**Your ref:** 22/1071/OUT

**RE: Outline planning application for residential development at Land East of Little Bushey Lane and North of the Squirrels, Little Bushey, Herts  
Planning Application Reference: 22/1071/OUT**

**Appendix A – Transport Note prepared by Velocity Transport Planning**

**Figure 7.17 Vertical visibility envelope.**

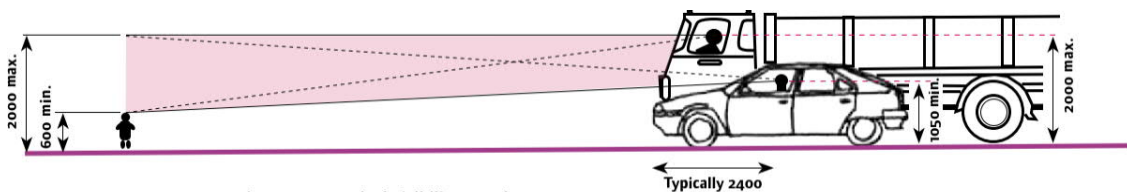
3.1.2 The drawing includes visibility splays drawn with a Y distance of 40m. This is the equivalent to a 30mph design speed according to Manual for Streets (Table 7.1) which is in line with the speed limit of the road and observed 85<sup>th</sup> percentile speeds. However, the drawing does not allow for the additional 2.4m bonnet length as recommended by MfS (see Table 7.1 and para 7.6.4). Extracts of the relevant parts of MfS are provided below for reference. This should be allowed for in the site access design.

7.6.4 The SSD figure relates to the position of the driver. However, the distance between the driver and the front of the vehicle is typically up to 2.4 m, which is a significant proportion of shorter stopping distances. It is therefore recommended that an allowance is made by adding 2.4 m to the SSD.

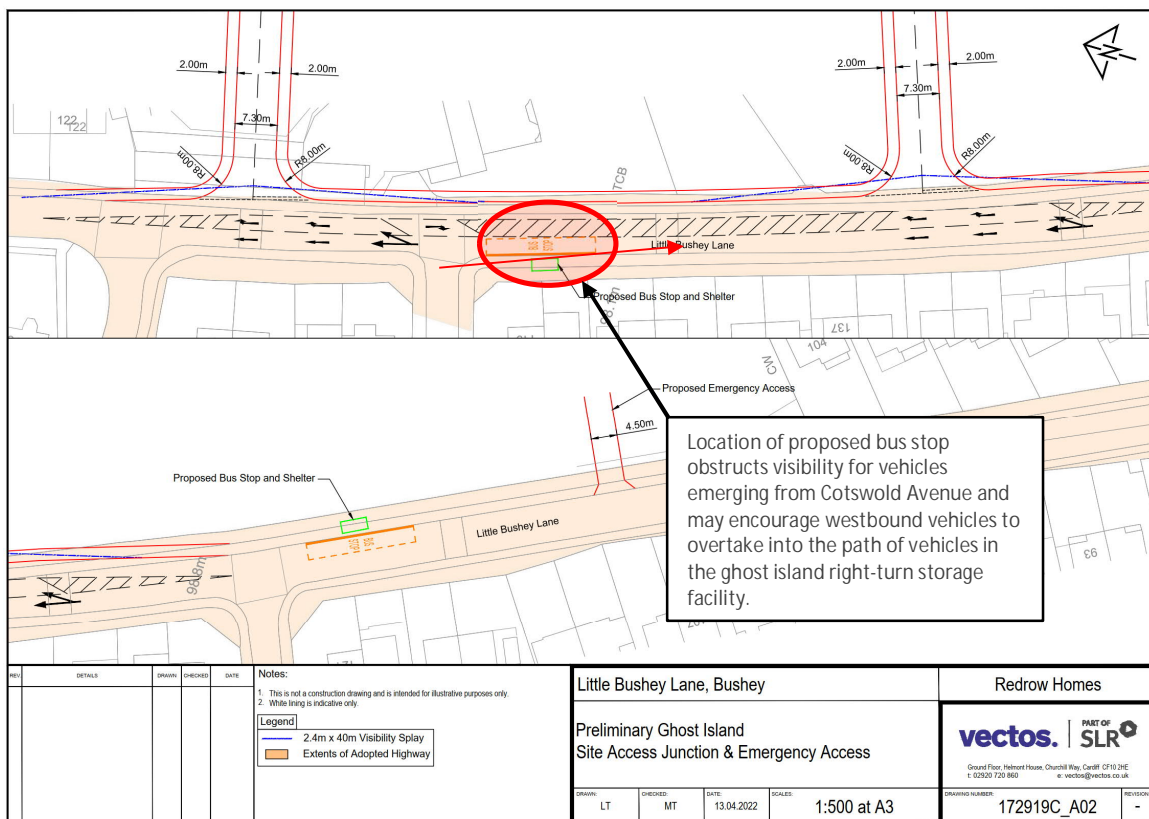
3.1.3 More concerning, however, is the impact of the proposed bus stop and shelter on the northbound side of Little Bushey Lane. With a bus in situ in the bus cage, it would effectively block the entire northbound lane. This would have the effect of encouraging following drivers around the bus into the chevron markings and into the opposing right-turn storage. There is therefore a significant risk with this arrangement of head-on collisions between opposing vehicles.

3.1.4 In addition, the presence of a bus at the proposed bus stop would obscure visibility for vehicles waiting to emerge from Cotswold Avenue onto Little Bushey Lane. These problems are illustrated below:

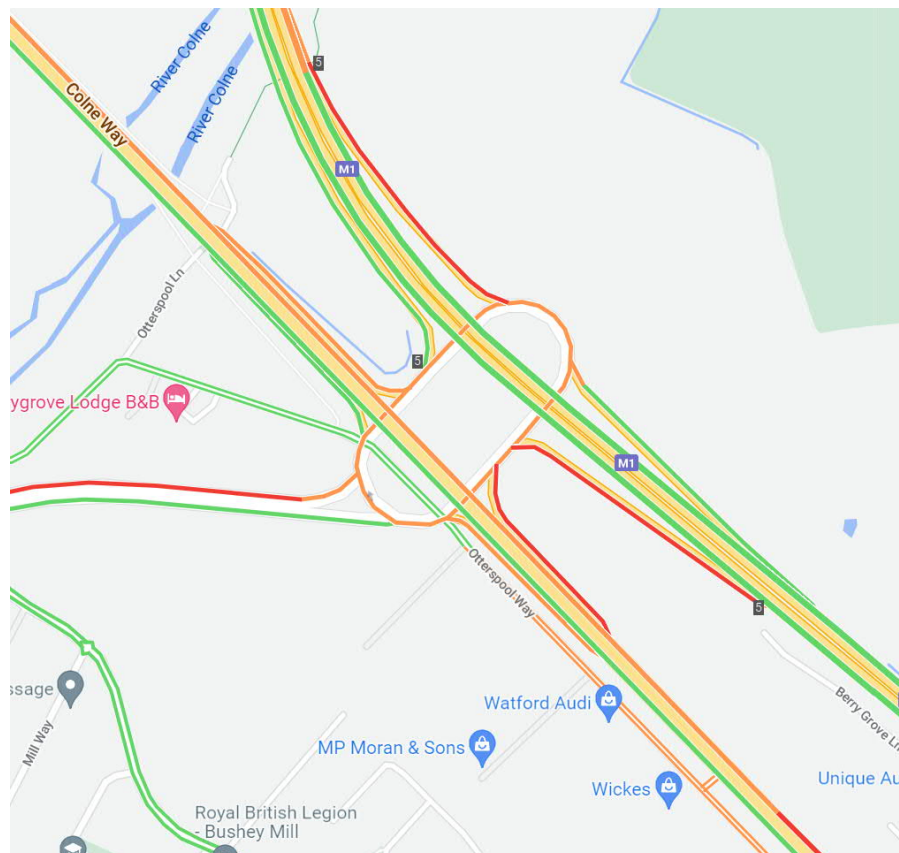
- ⊙ As they have not investigated how the junction currently operates, they are not able to rule out the possibility that it already operates using an optimised rather than fixed controlled. If they have, they have failed to provide any evidence of this.

- ⦿ The 2027 with development models use vehicular trip generation from the site which significantly underestimates its true trip generation potential due to the failure to consider first mode trips. As additional 53 two-way vehicular movements during each peak hour associated with first-mode travel have not been accounted for. These increase the site's vehicular trip generation by 27%.

5.1.14 Based on the above, the applicant has failed to properly assess the impact of the proposed development on the junction. What they have presented significantly under-estimates the impact but still shows it would be severe and unacceptable. The true impact would be even more severe.
